# SB2009 Proposal Document

vers. 20091201A

This report documents the resulting proposal from the Project Management Design Team for fundamental changes to the published RDR baseline, in accordance with the goals of the published GDE R&D Plan [ref]. It represents the culmination of approximately one-year of study and includes new results from the on-going risk-mitigating R&D, as well as a critical review of the existing Reference Design.

Figure 4.2.2: Schematic view of Wien filter proposal

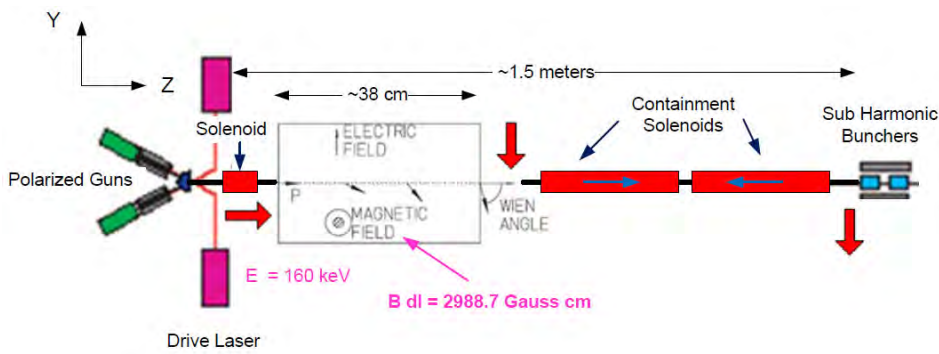
コメント [n1]: Could you quote a reference for this?

Figure 4.7.1: Proposed new layout of the electron BDS.

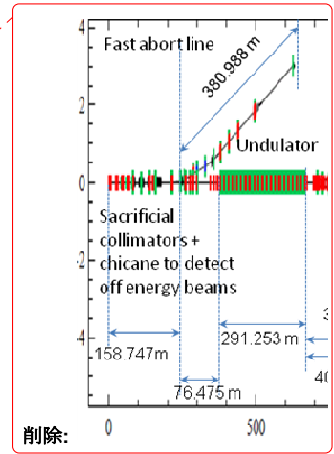
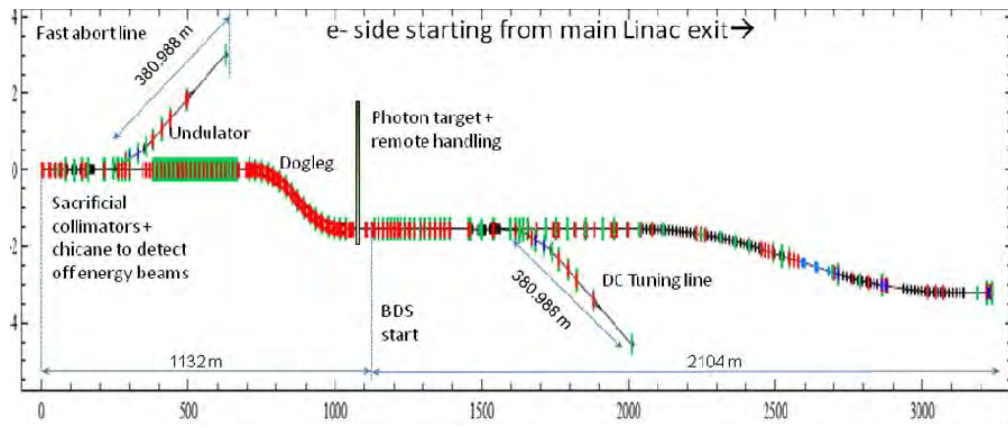
(I am not sure that we need to show all these distances (and upto the third decimal) on 4.7.1. I had included this figure in the initial draft as there were few confusions about this layout. Nobu, please let me know how you would like this figure to be modified and I will send you an update).
